Triple Apparels Ltd (Extension)

Holding 567, Block B, Ward no 06, Kewa, Sreepur PS, Gazipur-1740.
(24.212518, 90.431731)

5 October 2025

Observation-01: Prepared design report required to be reviewed by RSC. (Warehouse Building)

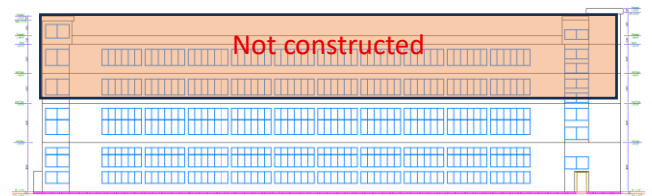
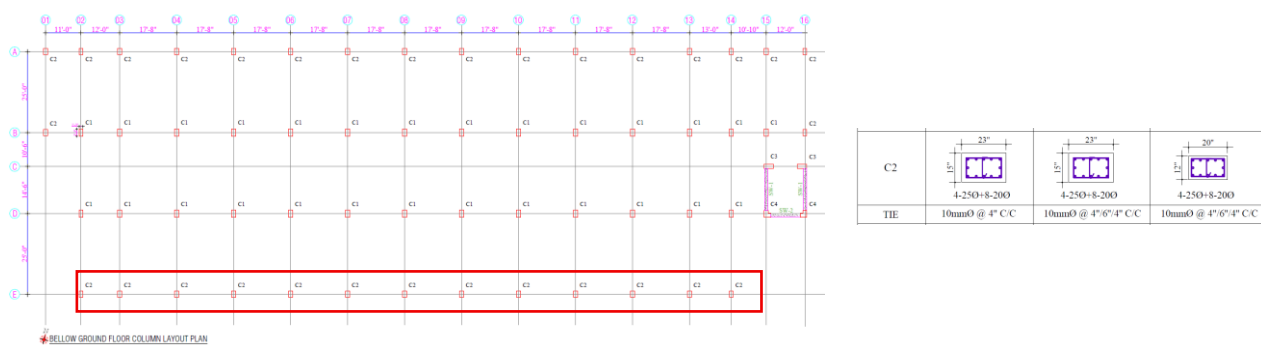
Description: A design report has been prepared for the four-story Warehouse Building. The prepared design report needs to be reviewed against lateral forces. Also, in the provided design report, the concrete compressive strength for columns and foundations is specified as 4000 psi. However, the available cylinder test reports appear to be insufficient to verify the concrete strength for these structural elements. The number of tests conducted does not meet the frequency requirements specified in the BNBC. The building engineer is required to justify the concrete strength in the design report by performing a core test and submitting the design report to the RSC for detailed review.

| Item No | Observation | Action Plan | Timeline |
|---------|---|---|-----------------|
| 1. | Prepared design report required to be reviewed by RSC. (Warehouse Building) | Verify in-situ concrete strength by taking 4-100 mm diameter concrete core from the column (lower level). Otherwise, provide an adequate number of cylinder test reports. | within 6 weeks |
| | | Submit the design report to the RSC for detailed review. | within 6 weeks |
